Application to the HISTORIC DISTRICT COMMISSION, Nantucket, Massachusetts, for a

CERTIFICATE OF APPROPRIATENESS

TAX MAP N^o: 76 4.1 PARCEL N^o: 1
Street & Number of Proposed Work: 21 Kendrick
Owner of record: Melanie Brunelle + Mark Swindle
Mailing Address: 580 W. Mermaid Lane
PHILADELPHIA PA 19118
Contact Phone #: _____ E-mail: _____

REVISIONS:

4 NEW WEST ELEVATION
 SCALE: 1/8" = 1'-0"

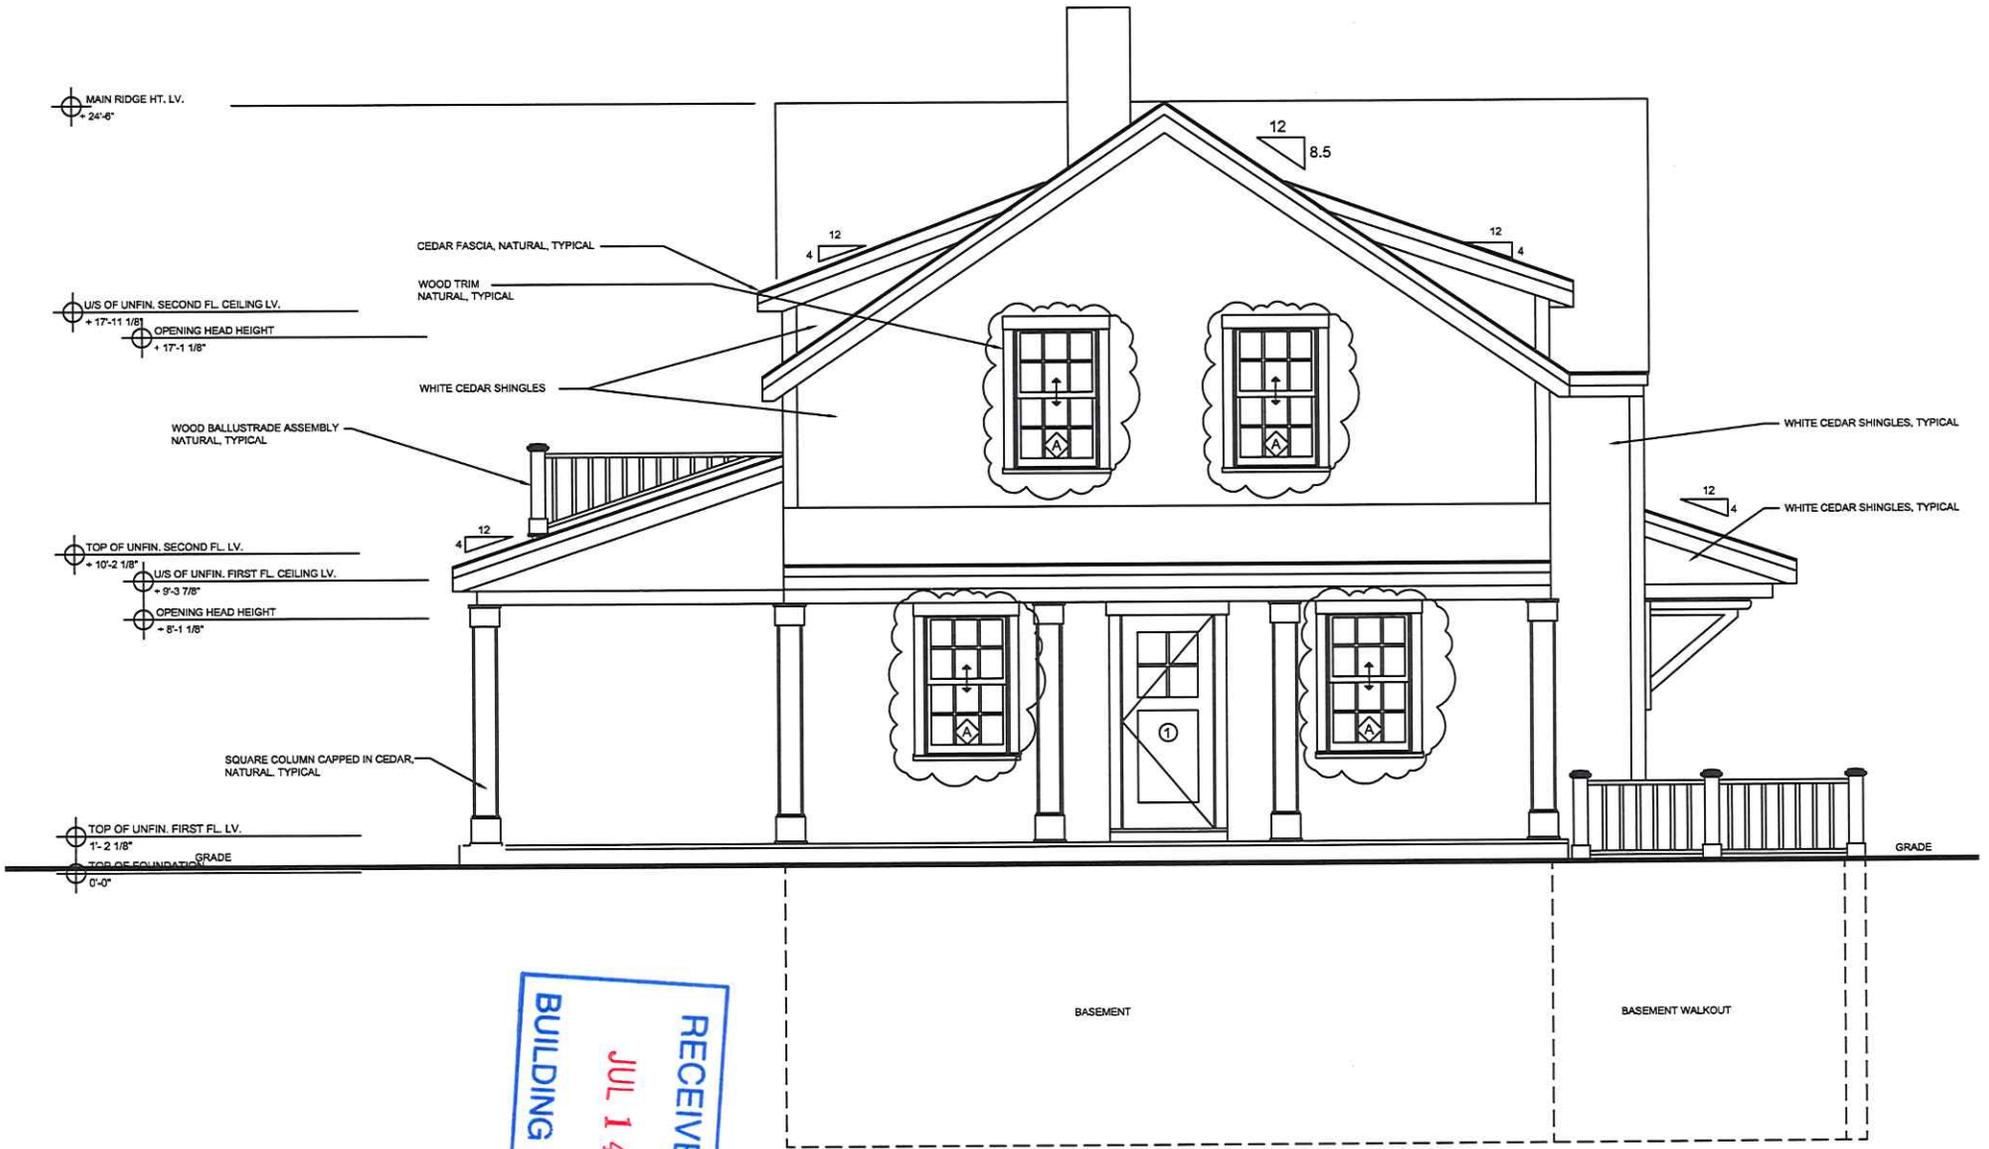
1. East Elevation Window change to 6/6
2. South Elevation reconfig Basement door/win, right side garage door to be French not roll up
3. West Elevation 2nd flr win reconfig.
4. North Elevation new 4 light win added - French Drs on 2nd flr to be sliders
